RIVER OAKS STATION ACCESS STUDY

Final Report – January 2026

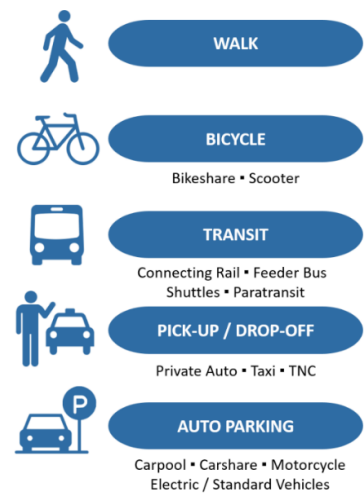
Previous Plan Review
